Update History

RP4.201 of NEC Series2 Cinema Projector adds new capabilities and corrects the issues below.

1-2. DCC Full- Auto Update

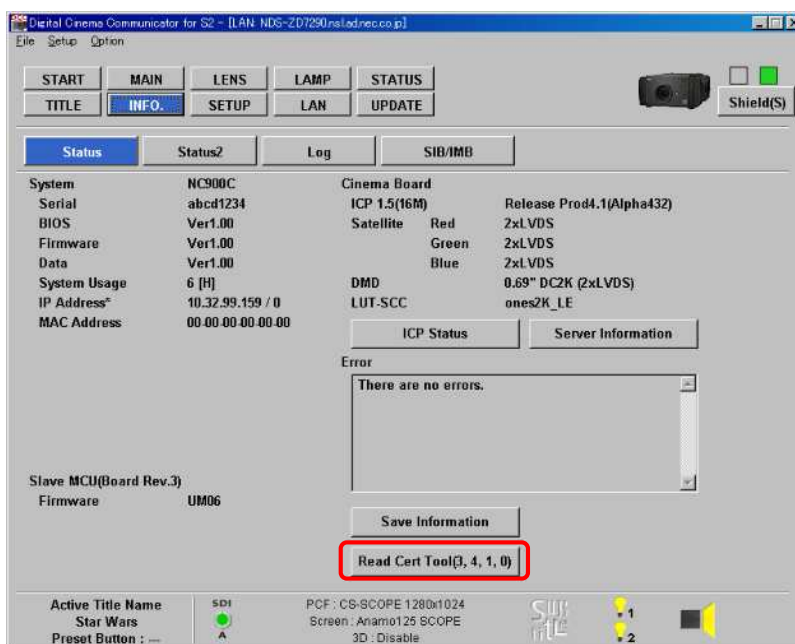
- The download of CPU DATA and Built-in DCC is dependently on Full-Auto update. In other words, need to download CPU DATA when only Built-in DCC download is required.
- Enigma Security Log will be cleared by Full-Auto update.

- Support to download CPU DATA and Built-in DCC independently on Full-Auto update.
- Enigma Security Log will not be cleared by Full-Auto update.

1-5. DCC-Save information-Include Usage Reset Log

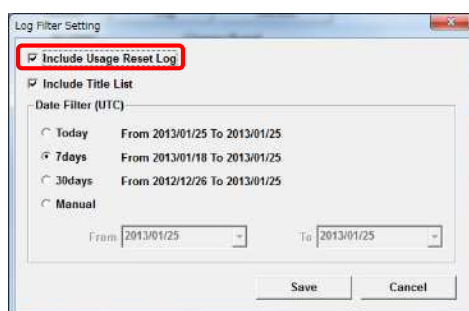
Change the default setting to “check on” as below.

1-6. Key Lock

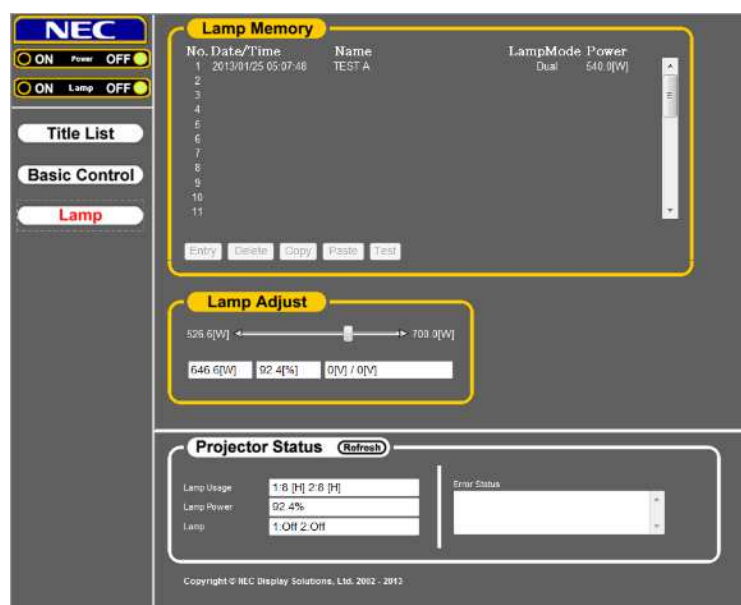
When Key Lock is cleared, LCD shows current menu again.

Before)

Home menu

After)

Keep menu

1-15. ICP S/W

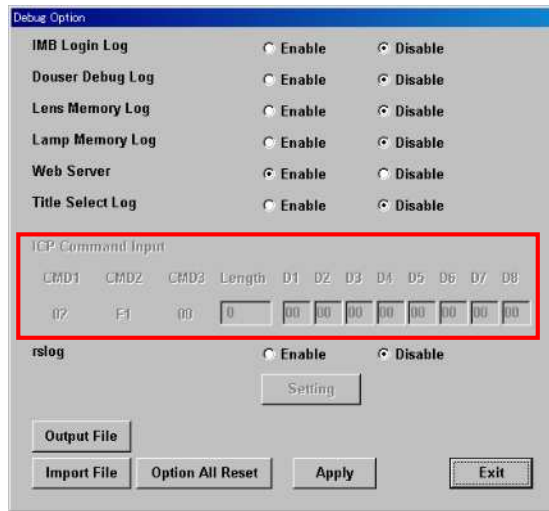
ICP S/W Prod4.2(Gamma) is applied to NC3240/NC3200 series.

(NC900, NC2000, and NC1200 are already applied.)

4-1. Lens Memory

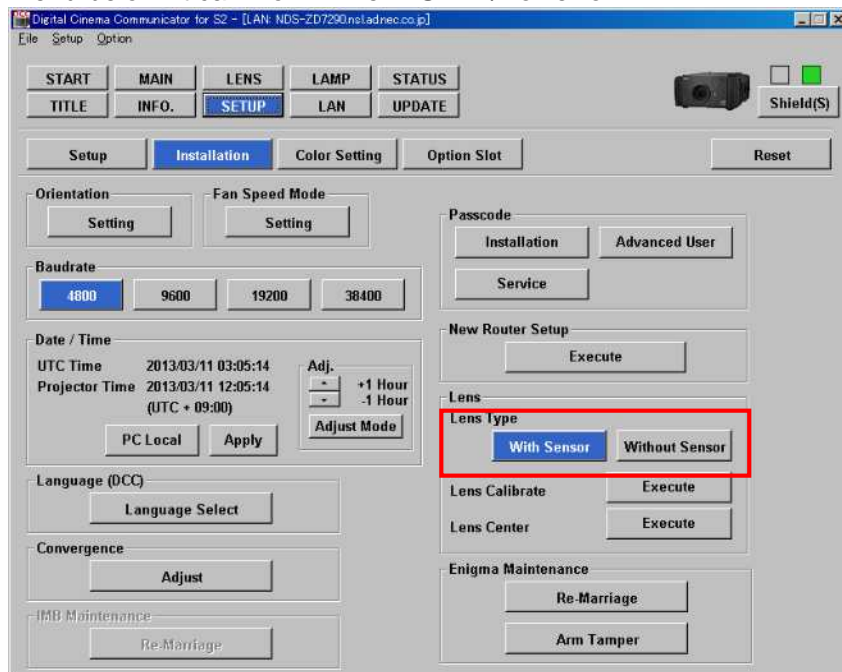
Support “Lens Memory” feature which is almost the same as NC2000/NC1200 series.

In NC900C, there are two types of lens(with/without sensor) supported.

The only lens with sensor is available for lens memory.

Lens Type setting

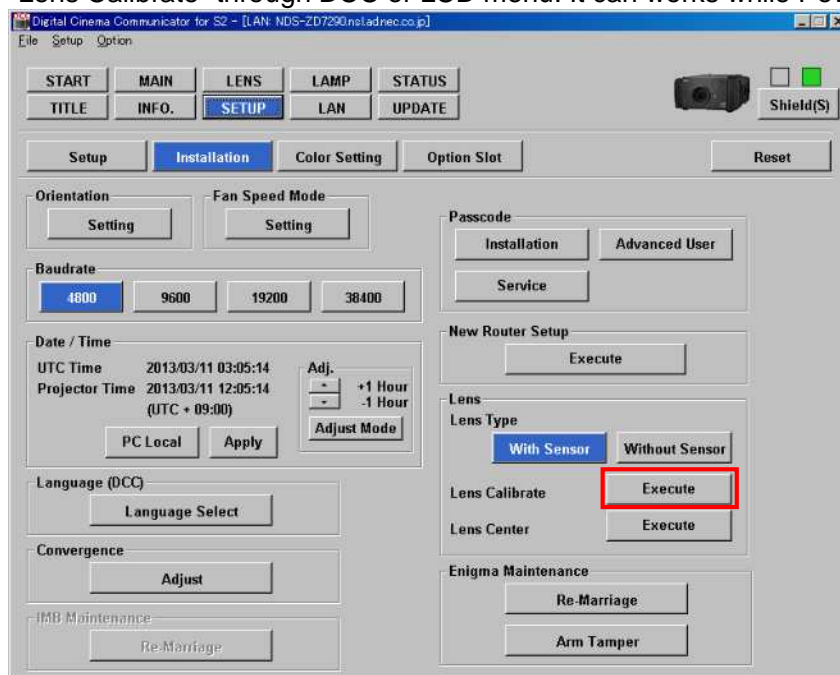
NC900 HW can not detect lens type, so user needs to setup lens type setting(with/without sensor) every when lens replacement. Here is the procedure to setup lens type. If it is not followed, the lens will not work.

1) When you change lens, you should setup lens type setting through either of DCC or LCD menu below. It can work while in STBY/Power-on.

With Sensor	Select when attaching lens with sensor.
Without Sensor	Select when attaching lens w/o sensor.(Default)

<Note>

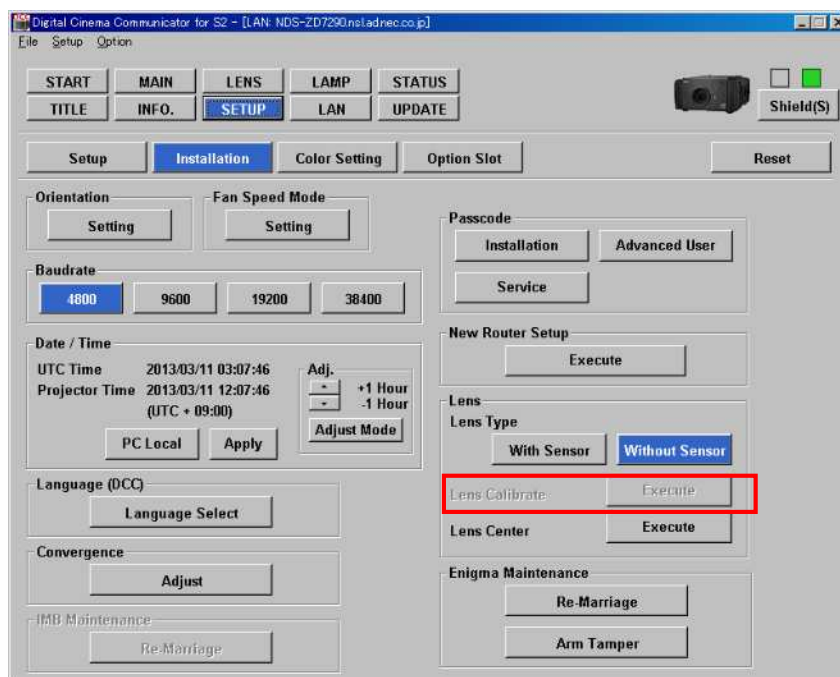
2) When you attach lens with sensor, make sure that lens type is “With sensor”. Then do “Lens Calibrate” through DCC or LCD menu. It can works while Power-on only.

1. If you setup <Without Sensor> as Lens Type, Lens Calibration feature can not work like below.

LCD menu(Information – Lens Type)

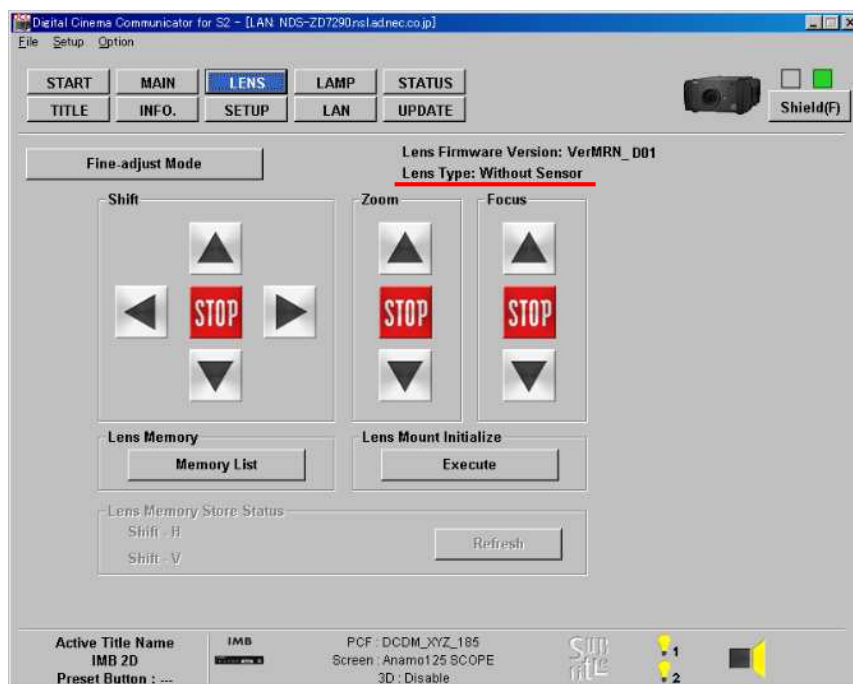
2. When lens w/o sensor is attached while lens type setting is “with sensor”, that lens will not work at all.
3. Current setting of Lens Type is shown on LCD/DCC/log like below. (They are available for user mode or higher.)

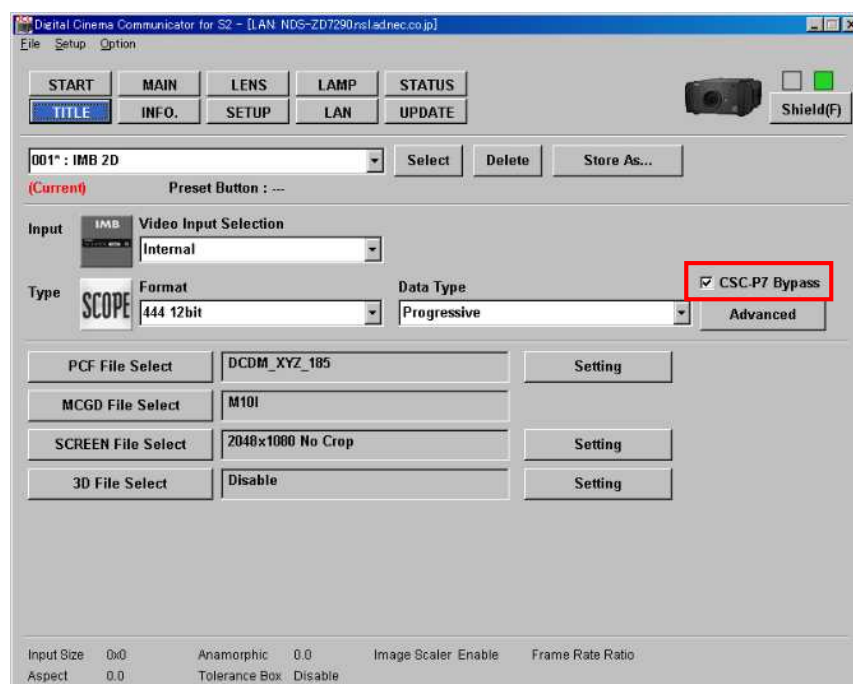
5. The old Lens Firmware, "MR_NXP_0316" and "MR_NXP_1120", does not support lens memory feature. In that case, update to "MRN_D**" version to support lens memory.(**: 01, 02, ...)

For update, follow the manual, "Lens_FW_Update_Proc_rev1.0.pdf".

4-2. CSC-P7 Bypass (NC900C only)

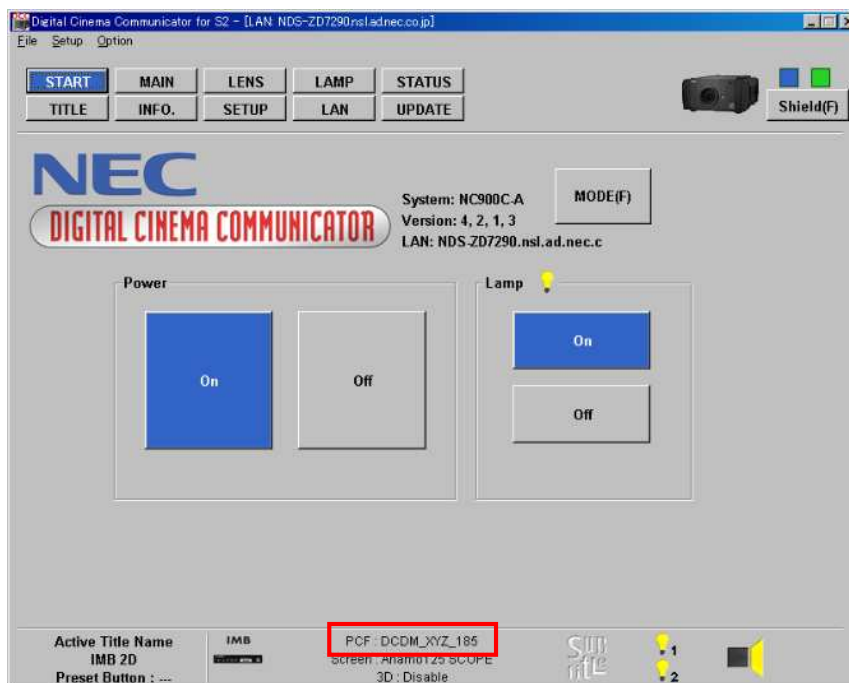
CSC-P7 correction can be enabled/disabled for each title through DCC-TITLE menu below.

If you want to get native color, check on "CSC-P7 Bypass". (*)

1. LUT-CLUT, LUT-DG can not be disabled in this function.
2. While "CSC-P7 Bypass" is check on, user can configure PCF/MCGD setting. However, color correction is disabled.(CSC-P7 hardware is disabled).
3. While "CSC-P7 Bypass" is check on, PCF file name corresponding to the current title shows up on DCC like below.

4-3. MCGD brightness

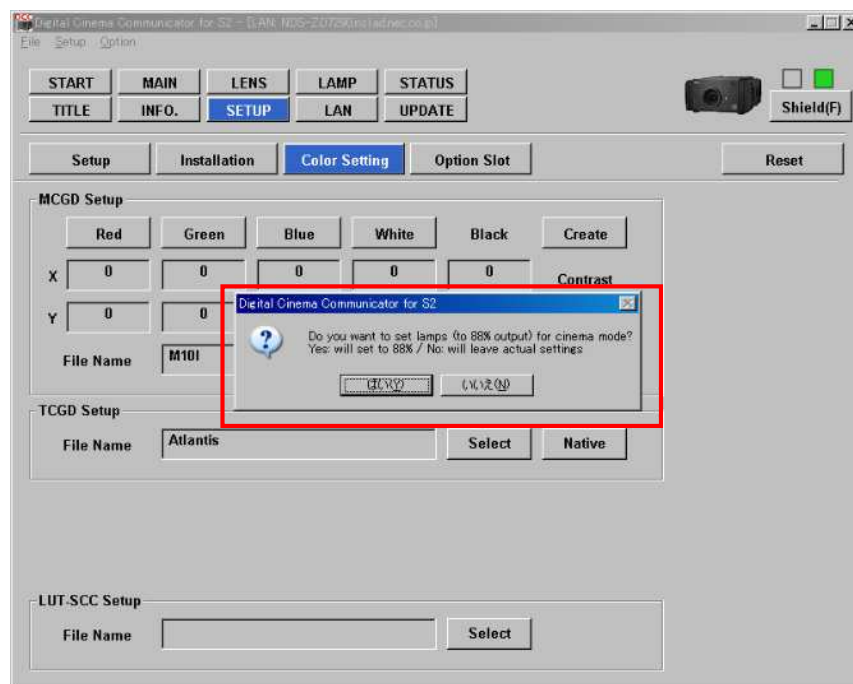
In NC900C, NEC recommends to set 88% brightness for MCGD.

Because the measured value with 88% will cover lamp power ranging from min to max.

When click on [Create] button of MCGD Setup, the below message will show up.

If you click on [Yes], then projector will set 88% brightness automatically. And message is stored in operation log like below.
